TAX ID # 03-317722
ON-SITE SEWAGE DISPOSAL SYSTEM
HOWARD COUNTY HEALTH DEPARTMENT
BUREAU OF ENVIRONMENTAL HEALTH

SUBDIVISION: Hawksfield Estates LOT NUMBER: 17

ADDRESS: 3115 Old Oak Drive PROPERTY OWNER: George & Laura Mamo

Approved Septic System Plan
Howard County Health Department

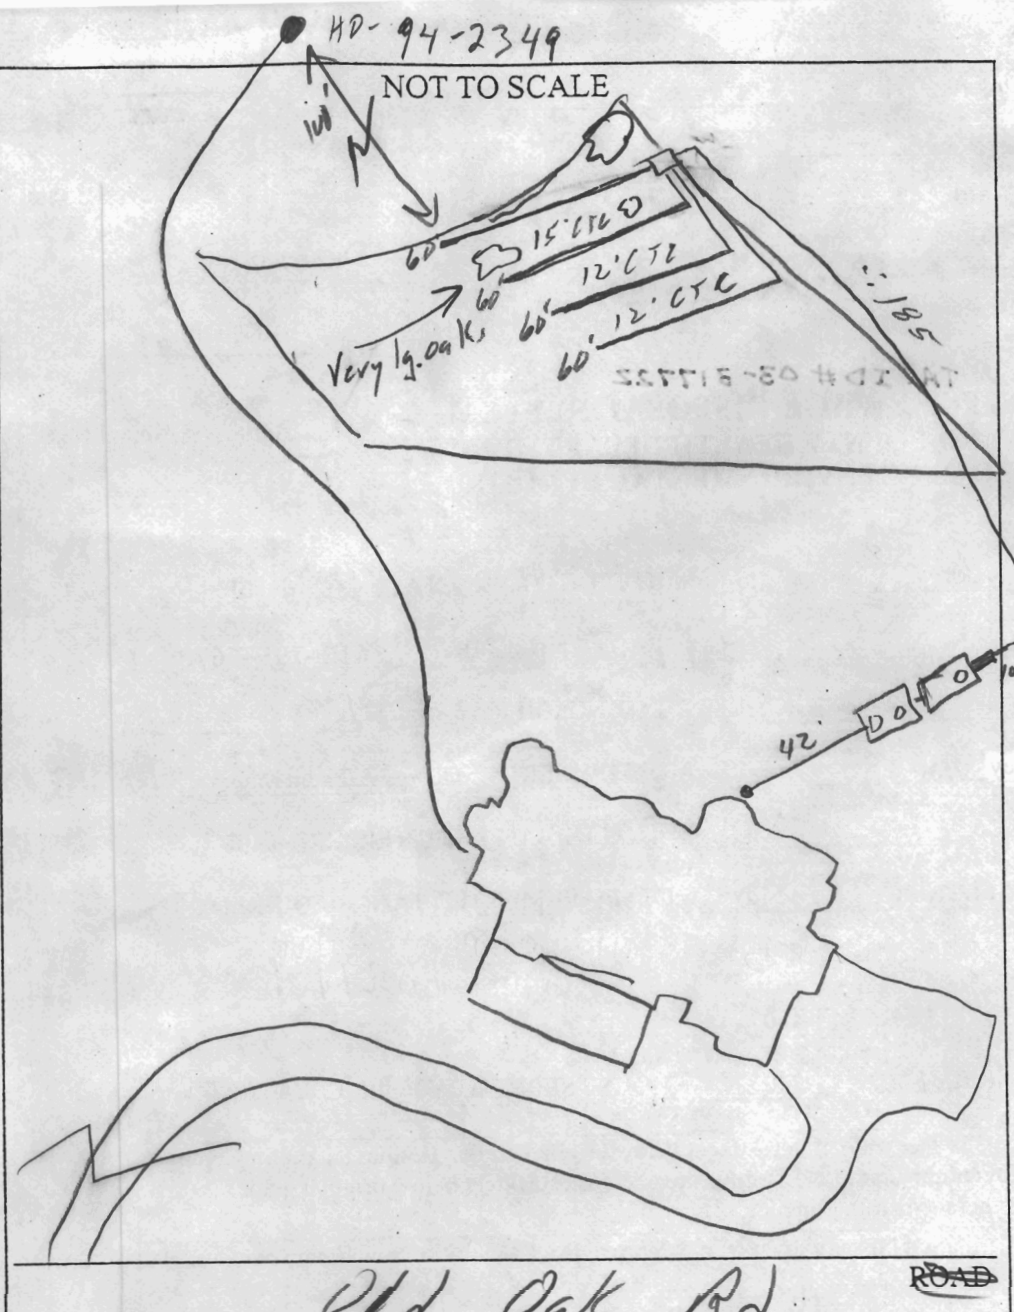
SEPTIC TANK CAPACITY (GALLONS): 1250 ¹⁵⁰⁰ OUTLET BAFFLE FILTER REQUIRED

PUMP CHAMBER CAPACITY (GALLONS): 1250 ¹⁵⁰⁰ COMPARTMENTED TANK REQUIRED

NUMBER OF BEDROOMS: 45

House modified by owner on 6/1/04

PRE-CONSTRUCTION 10/28/04 - SRA staked, contours accurate, one very lg oak tree in upper SRA, OK to do 15' CTC around this
 INSTALLATION tree. Trench (4) 60' (SD)
11/1/04 - Complete system installed. House conn, Pump & Alarm tests needed (SD) 5/23/06 Pump and alarm working. (BB)

PLAN VIEW
SCALE: 1"=100'

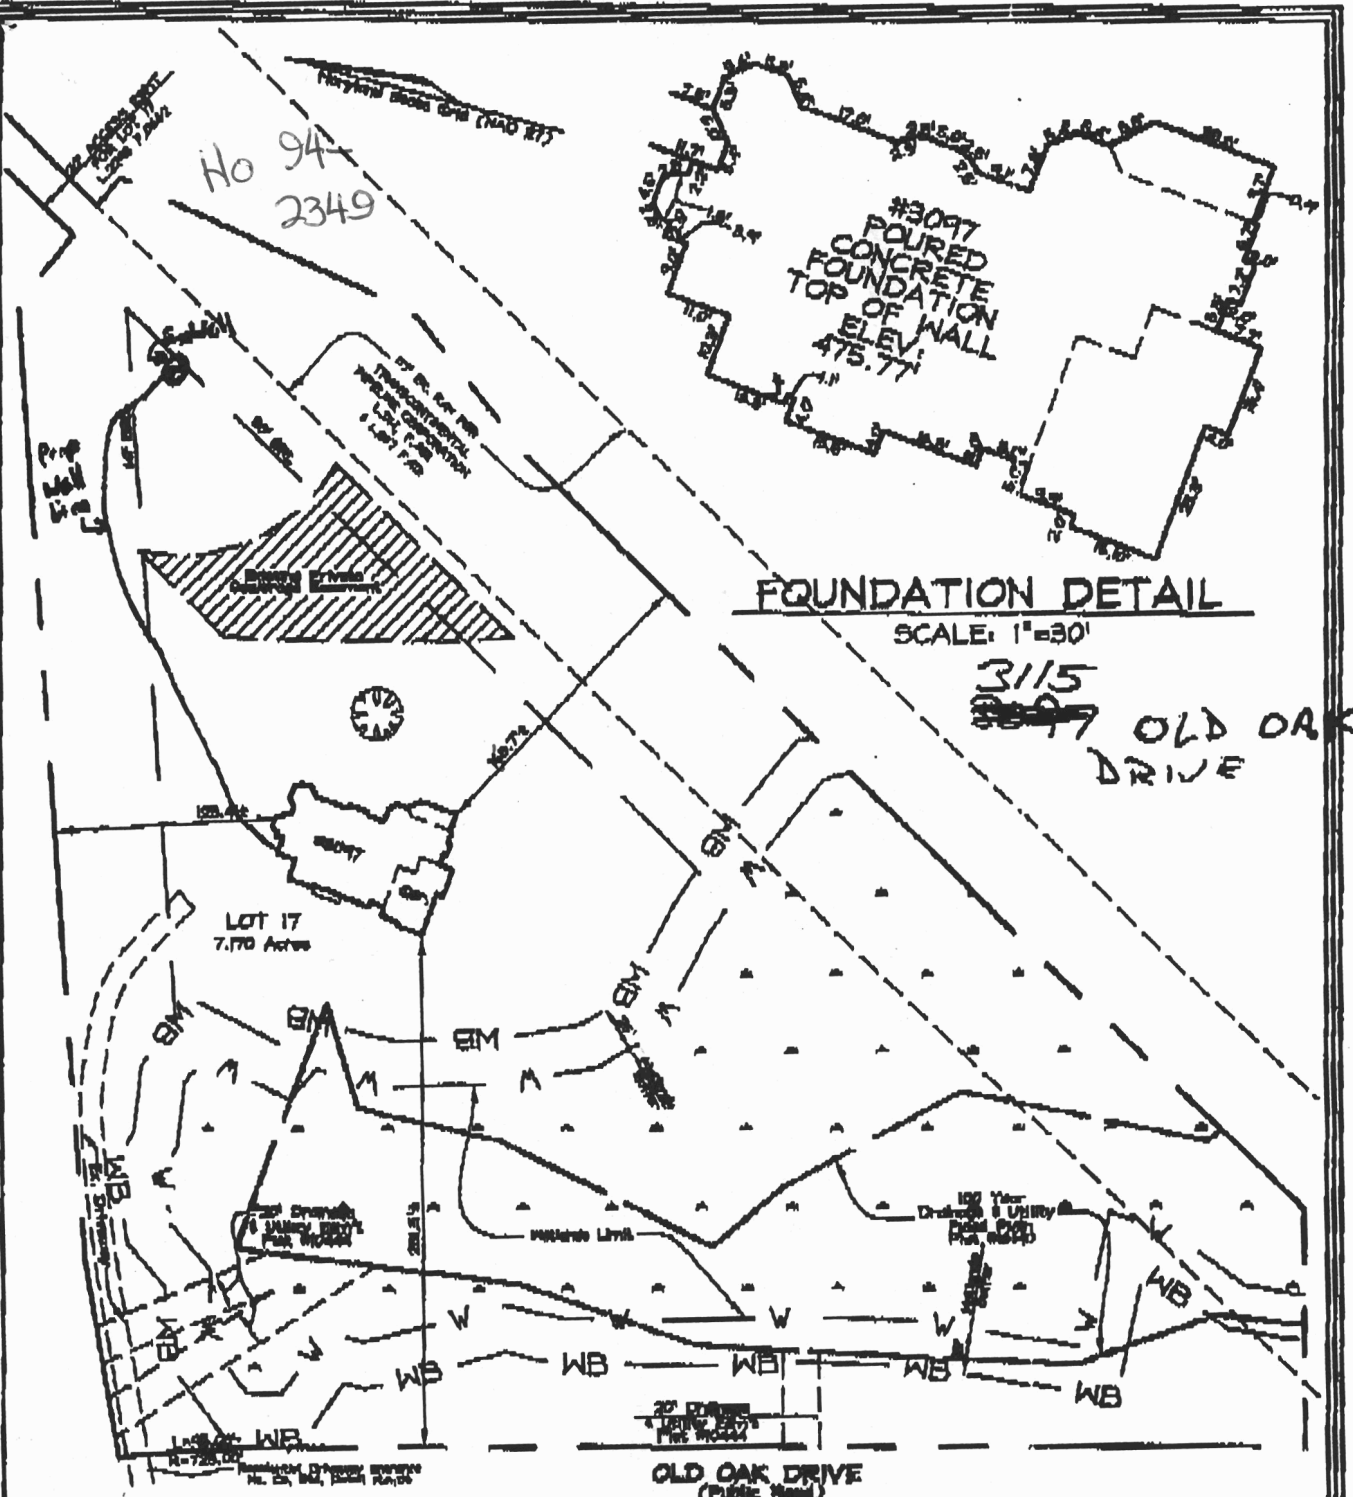
8/13/04
House moved (N, NE)
10±' Wall check
OR
KJB

Revised plan ok
Racu Roman
Signature
4/4/04
Date
